PART 21 - BARTON MODEL 288A AND 289A DIFFERENTIAL PRESSURE SWITCH DEFECT

PRODUCT ADVISORY

Model 288A and 289A Differential Pressure Switch Defect

DOCUMENT NO.: 210036966.01

MODEL 288A/289A SWITCH OPERATING MECHANISM MOCKUP

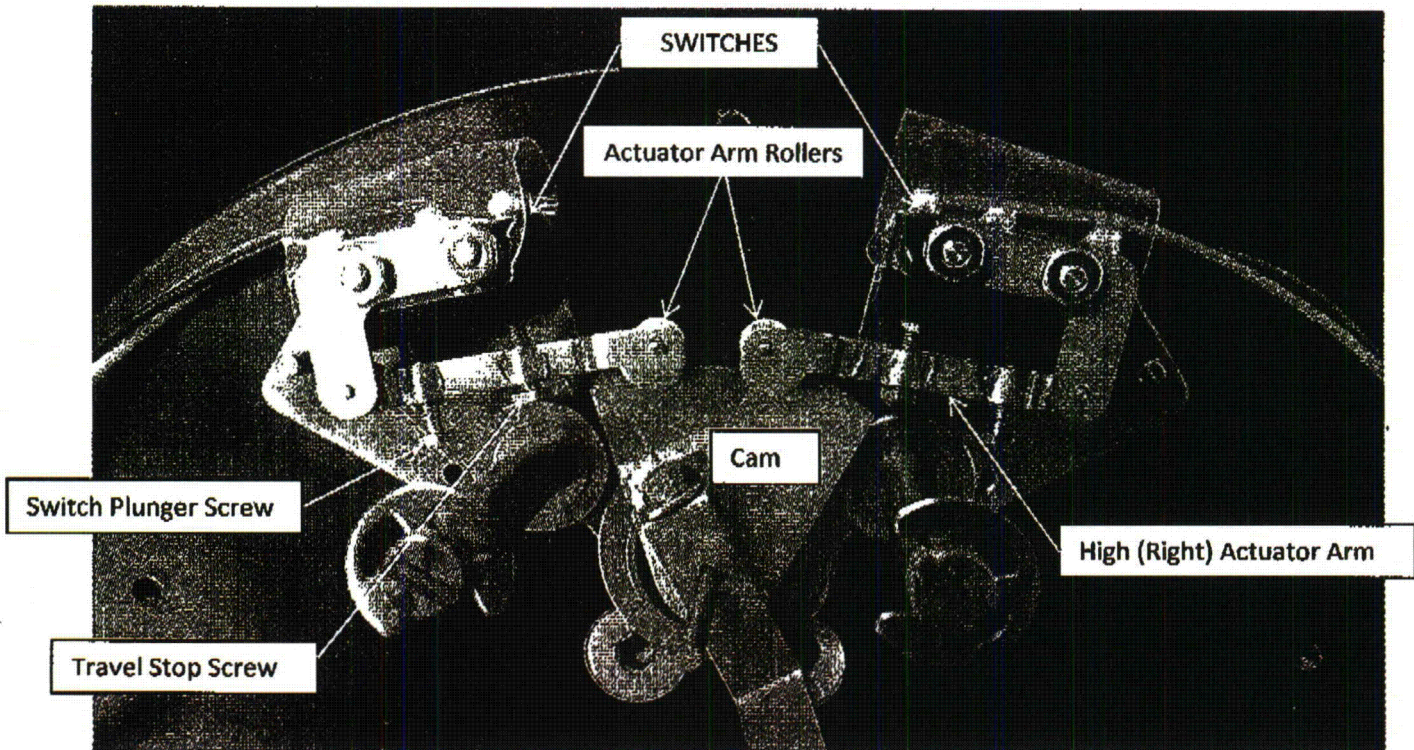
During the investigation of an apparent setpoint drift issue on Model 289A Indicating Switches at an operating nuclear power plant, Cameron uncovered an out-of-specification concentricity issue with the switch actuator roller that rides on the switch operating cam. No other utilities have reported a similar issue.

With the nonconforming rollers, a switch can still operate within the repeatability specification of 0.25% as long as the roller radial position remains the same when at the switch trip position. However, if the radial position of the roller changes (due to vibration, multiple fluctuations in the sensed differential pressure that causes the roller to move off and on the cam high point, etc.) then the switch can trip at a different value. Based on a sample of approximately 100 rollers inspected, a maximum repeatability error in the neighborhood of 2% has been observed. It is expected that the tolerance would be cyclical if the roller moves to new positions, with both increasing and decreasing values recorded over time.

Due to the nature of this concentricity issue, it warrants immediate notification so that appropriate utility evaluation and remedial action can be implemented. Until such time that final reviews of the above utility identified setpoint drift concern are completed, Cameron recommends that utilities perform increased switch setpoint verifications especially where historical records indicate repeatability issues.
